Addendum #2

Bid Opportunity: 24-7536-RFT - Margaret Ave. Public School -HVAC Upgrades,

PROJECT:
22368
MARGARET AVENUE PUBLIC SCHOOL RENOV.

ADDENDUM 02

DEMOLITION DRAWING.

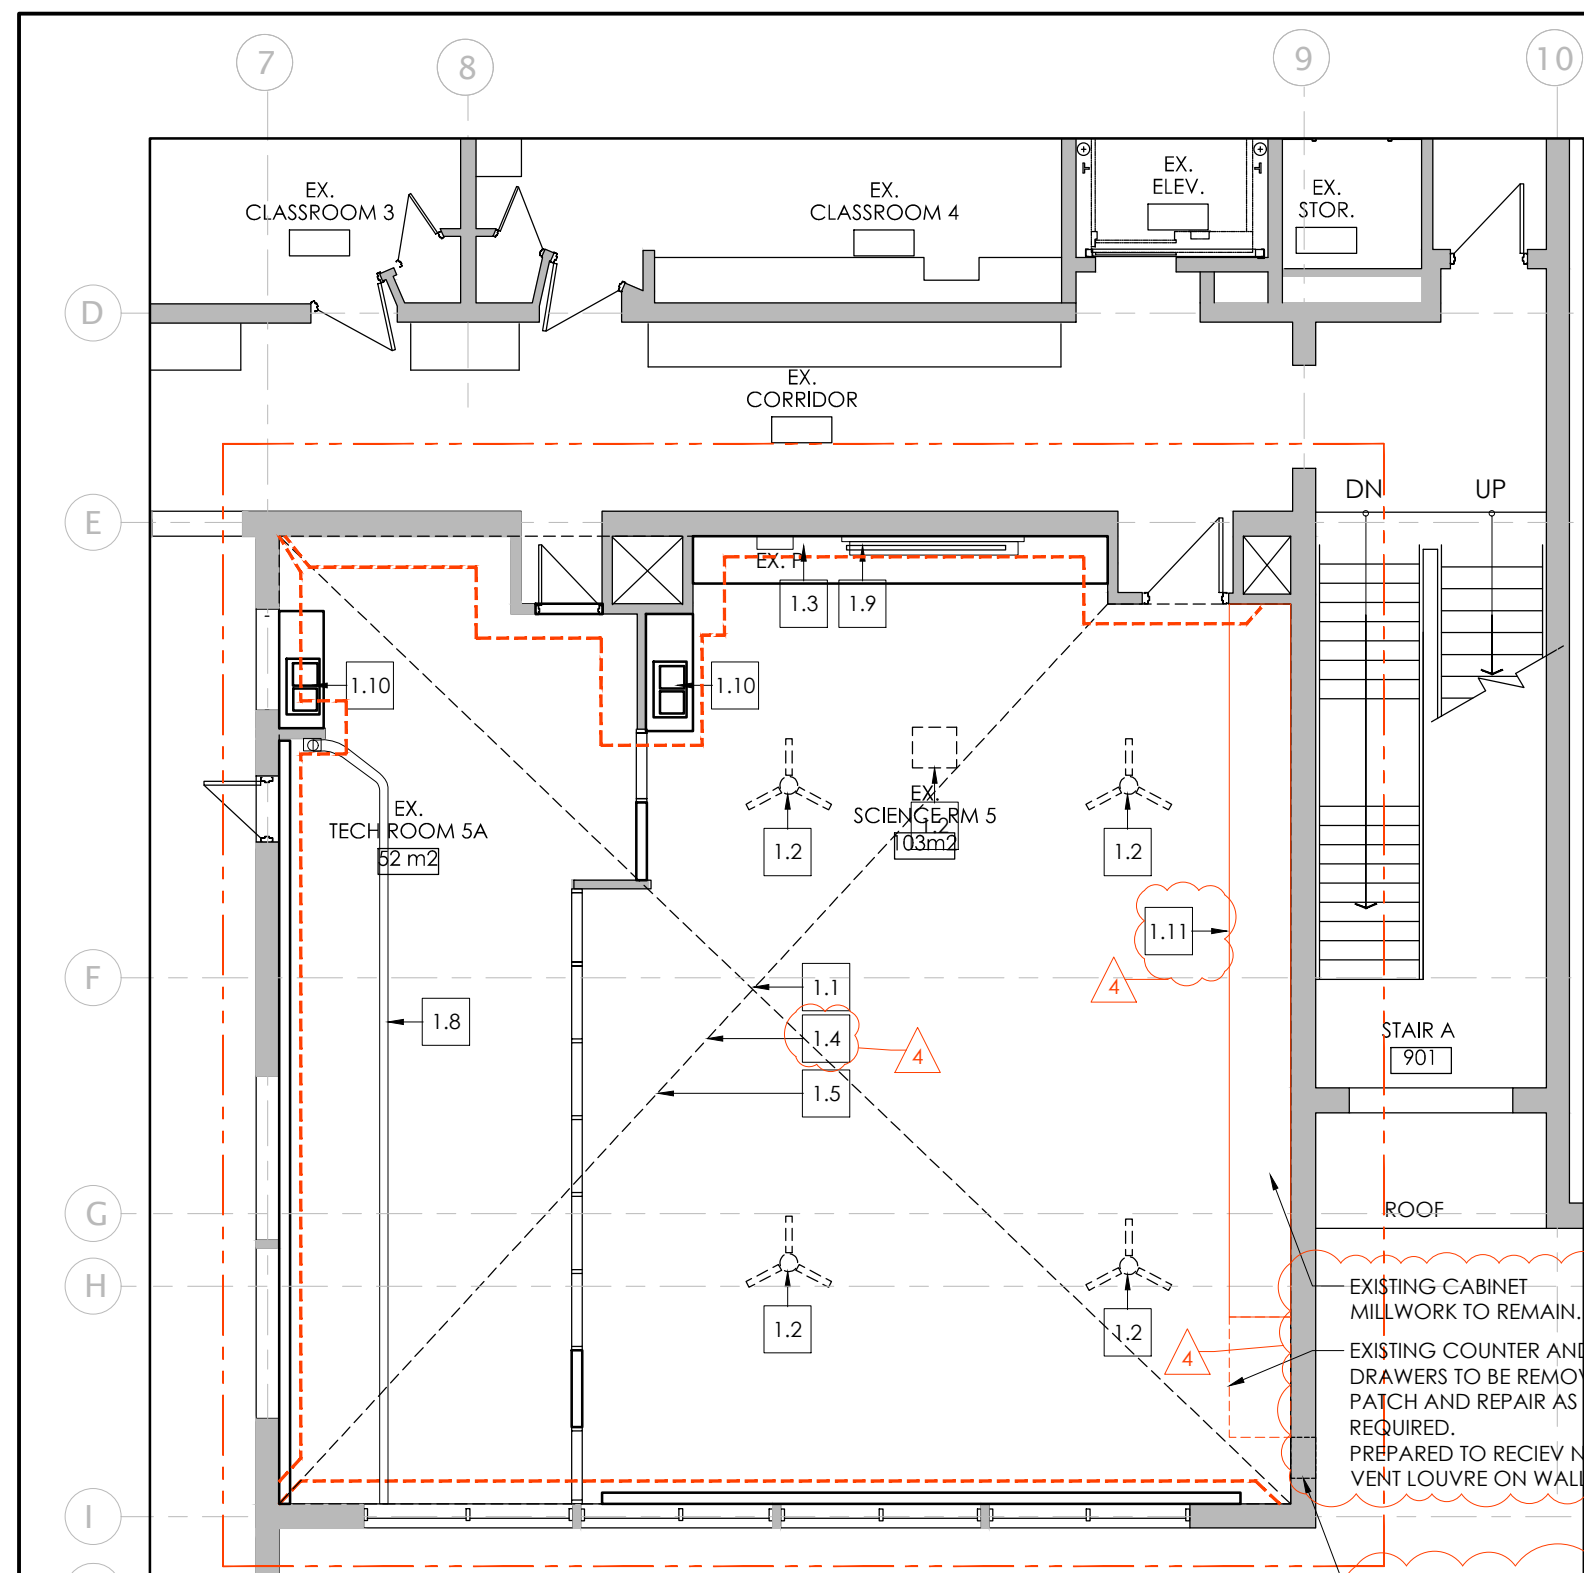
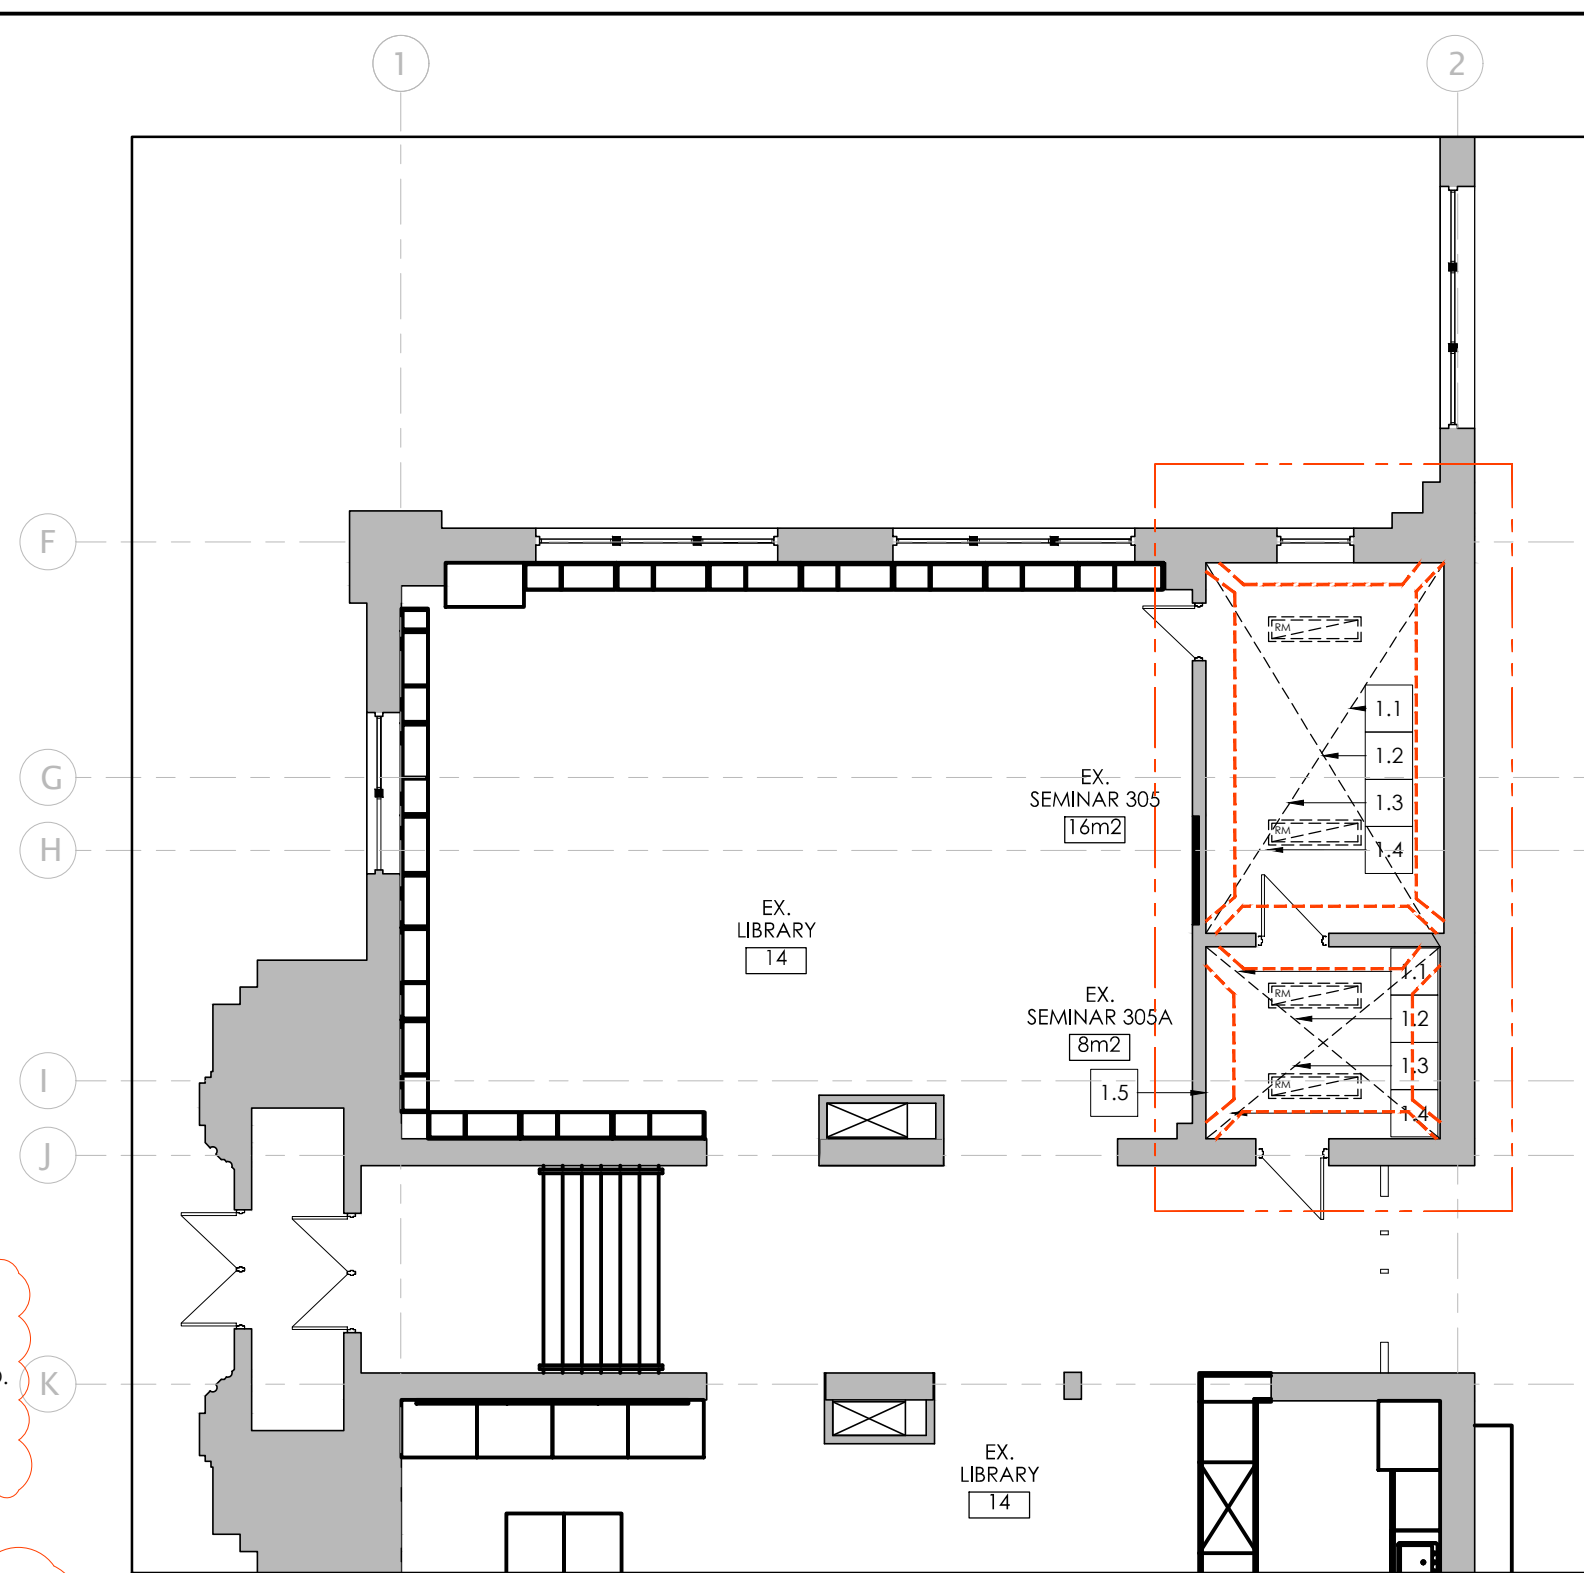
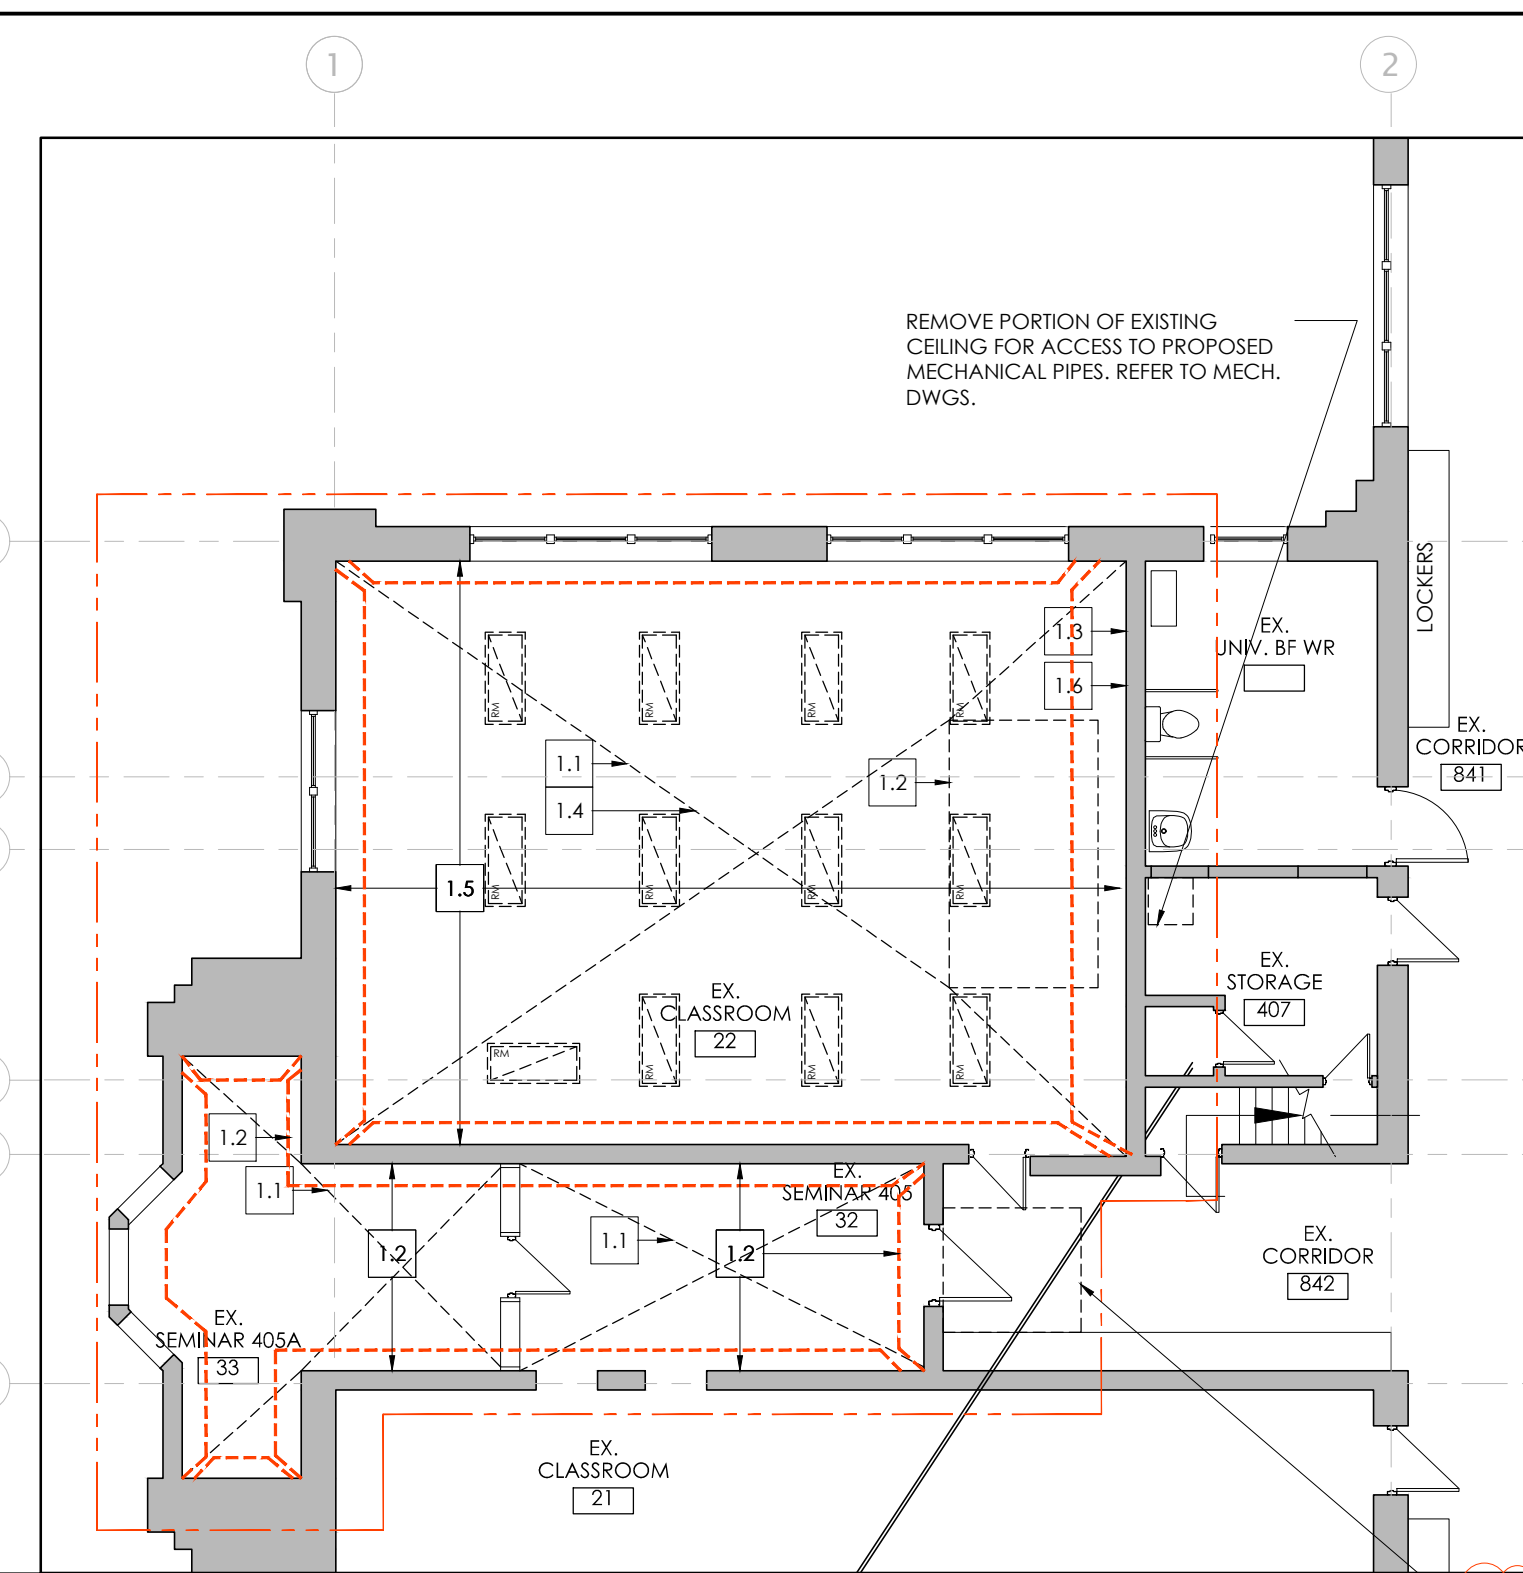
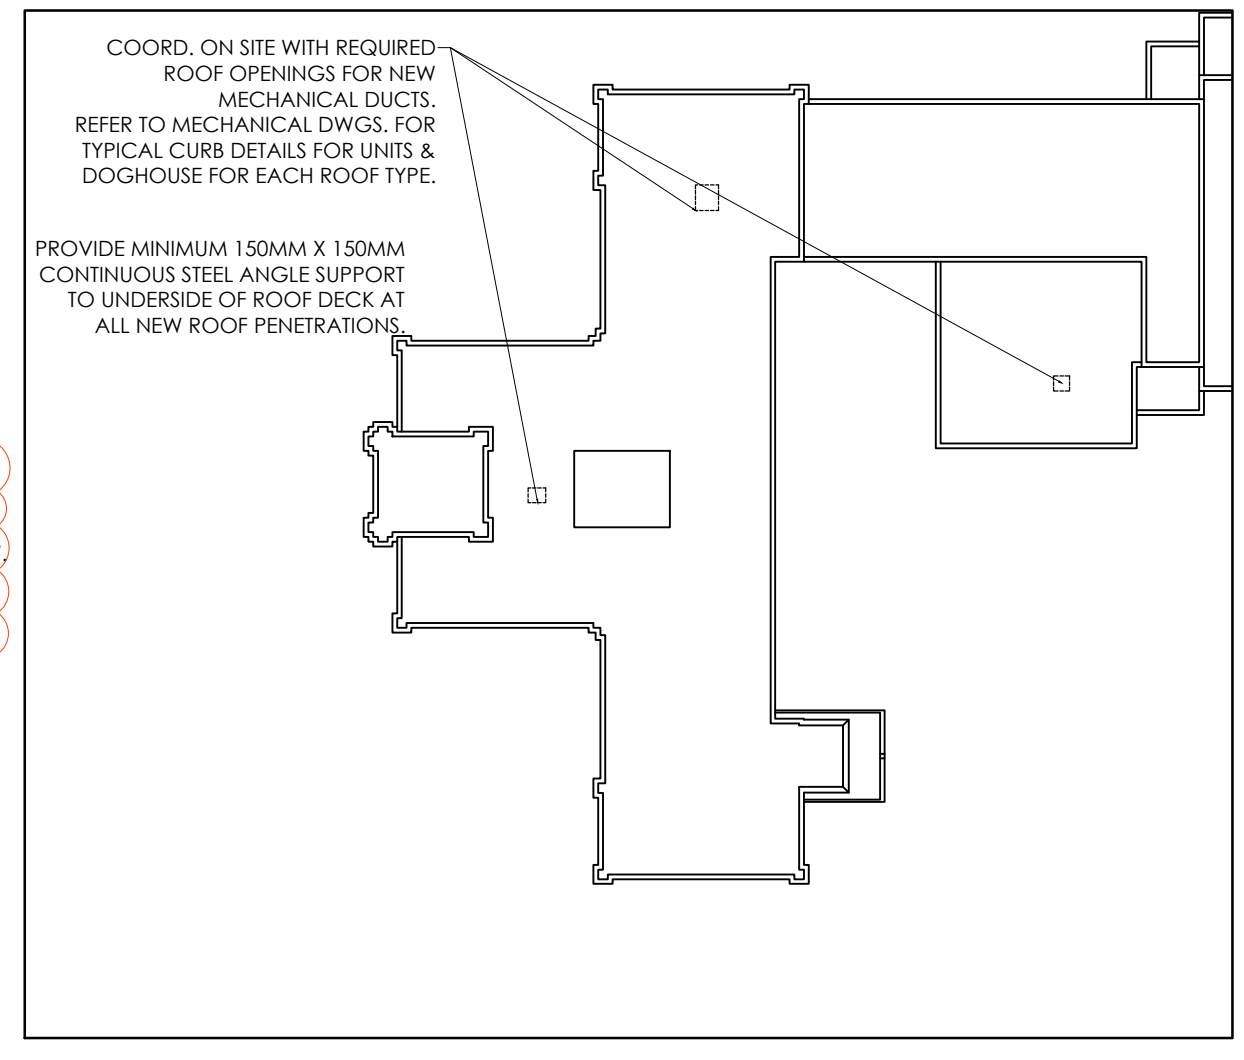
1.
 - i. DELETE drawing **AD2.1 DEMOLITION DRAWING.**
 - ii. REPLACE with attached updated drawing **AD2.1 DEMOLITION DRAWING.**
2.
 - i. DELETE drawing **A2.1 PARTIAL FLOOR PLANS RENOVATIONS**
 - ii. REPLACE with attached updated drawing **A2.1 PARTIAL FLOOR PLANS RENOVATIONS.**
